APPENDIX A

DRAFT MITIGATED NEGATIVE DECLARATION PUBLIC COMMENTS

NOTICE OF INTENT TO ADOPT A MITIGATED NEGATIVE DECLARATION FOR THE POINT VIEW MASTER USE PLAN, THREE DISTINCT COMPONENTS, 1 THE EXPANSION OF THE AGRICULTURAL US; 2 DEVELOPMENT OF A PRIVATE EXECUTIVE GOLF COURE; 3 IMPROVEMENTS TO AN EXISTING LANDSCAPED PATIO/EVENT GARDEN AREA; 6001 PALOS VERDES DRIVE SOUTH, RANCHO PALOS VERDES (FFER #201200055)

Subject: Draft Mitigated Negative Declaration for the Point View Master Use Plan (SCH #2012041048, ZON2010-00087), City of Rancho Palos Verdes, Los Angeles County, California

Composite map of Master Plan map and map of NCCP Preserve Properties Lower Filiorum Potential Preserve

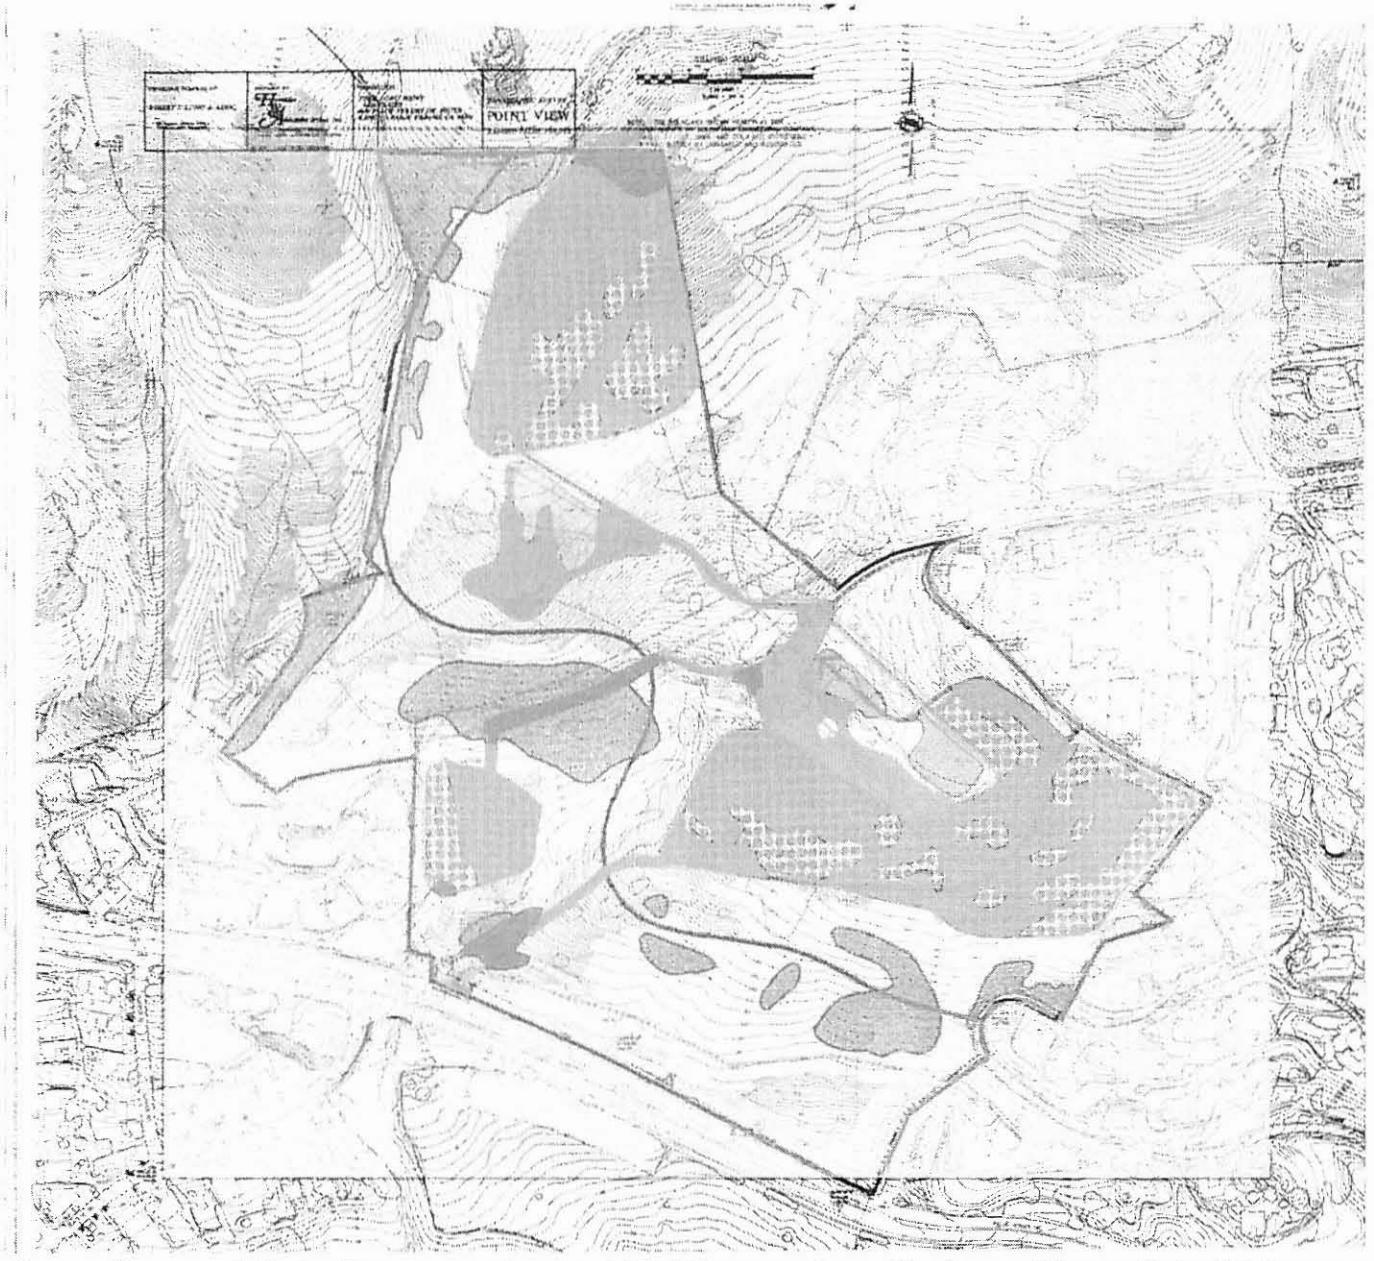
The entire Point View site is mapped in the NCCP as a Regionally Important Habitat Area and Linkage Planning Area (NCCP Figure 2-4) and as a Priority Habitat Restoration Area within the Reserve (NCCP Figure 6-1). Because of those important habitat values, Section 3.1.2 of the NCCP specifically addresses mitigation required at the Lower Filiorum / Point View project site as follows:

The MND completely ignores this relevant Section of the NCCP and instead pretends that the site should be considered a "*Neutral Land*" because "*similar grasslands in the adjacent Barkentine Canyon are designated by the NCCP as being 'Neutral Land', not accessible for active habitat management and not included in the NCCP Reserve area*". (p.B-29) The MND's argument is completely illogical for three reasons: Barkentine is not mapped as Neutral Land (NCCP Figure 4.3); Barkentine Canyon is indeed included in the Preserve; and the Point View property does not meet the criteria for the definition Neutral Lands as stated in Section 4.1.3 of the NCCP:
